# Recall Campaign Bulletin

Campaign No. 2024010011, April 2024

Revision C: 06/14/2024

## **Replace Fuel Pump Delivery Module – Wave 3**

Figure 2

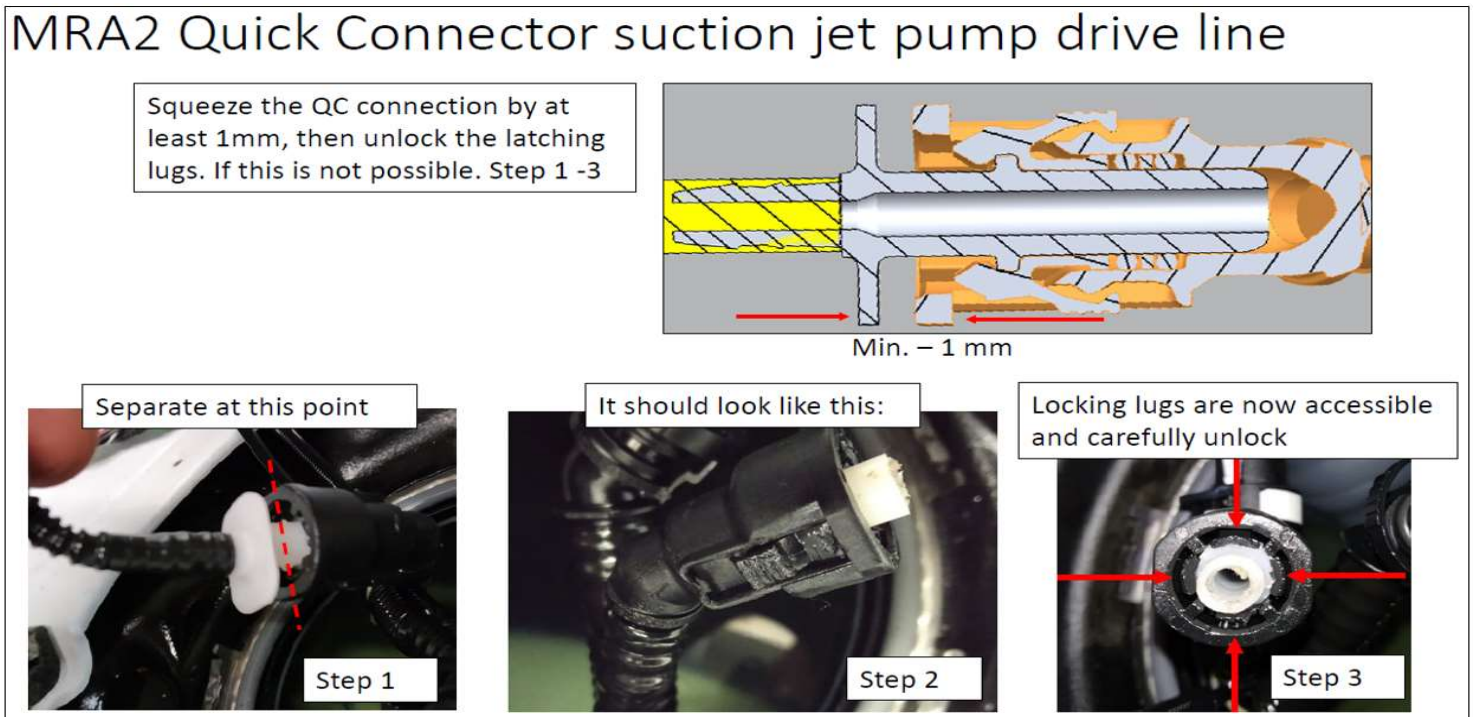
**i** **Only model 206, 232:** Note on disassembly of suction jet pump drive line quick connector.

The procedure steps 1-3 should only be performed when the quick disconnect is not working (**Figure 2**).

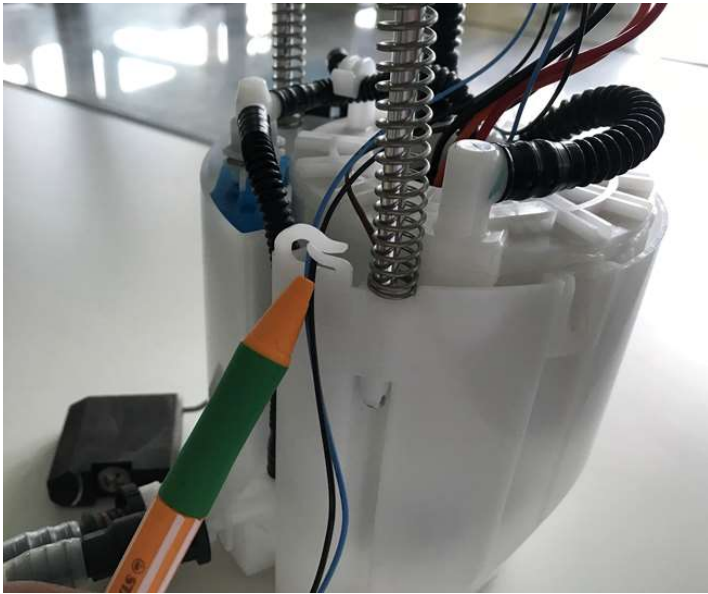
**i** **Only for model 167**

Contrary to the WIS document (**AR88.60-P-2001ME - Remove/install tank filler recess**), the tank filler recess must **not** be removed. Disconnecting the hose lines at the activated charcoal canister and the sealing bellows on the inside at the tank filler recess is sufficient.

**Figure 3**

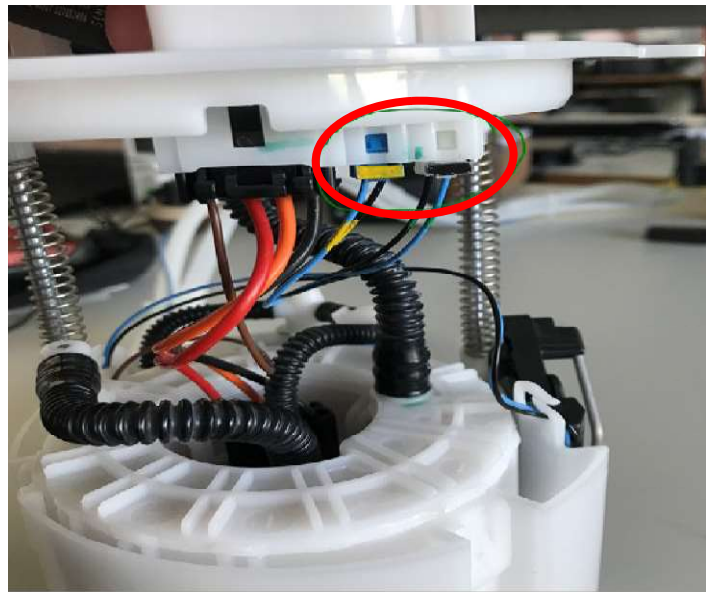
**i** For **all** vehicles with code 228 stationary heater, the connection for the fuel supply system must be cut off before installing the fuel pump (**Figure 3**).

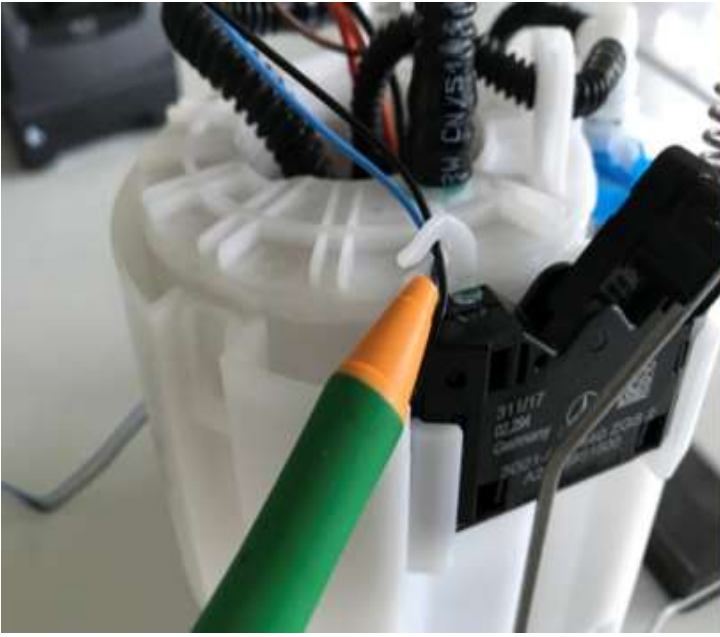
**i** Delivery modules that are delivered **without float-and-lever sensor** must be modified. (**Figure 4-7**)

**Figure 4** (remove electric lines from routing clip)

**Figure 5** (release corresponding connector and disconnect the contacts)

**Figure 6** (remove lines from routing clip)

**Figure 7** (using a screwdriver, carefully push float-and-lever sensor housing away from module housing and at the same time push float-and-lever sensor housing upwards.)
